## Determination 2010/033

### Determination regarding the refusal to issue a code compliance certificate for a 6-year-old block of three semi-detached townhouses at 16, 18 and 20 Kora Avenue, Waitakere City

3.1 The following site plan shows Block G:

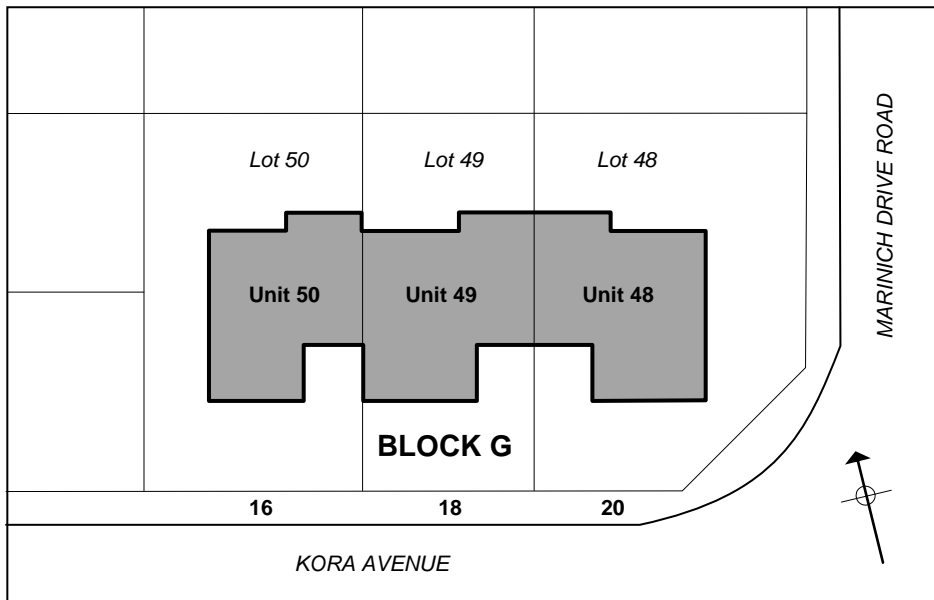
3.2 Block G is a two-storey building situated on a flat site in a low wind zone in terms of NZS 3604<sup>4</sup>. The block sits at the corner of Korā Avenue, with the main entries and garage doors facing south towards the road. The building is fairly simple in plan and
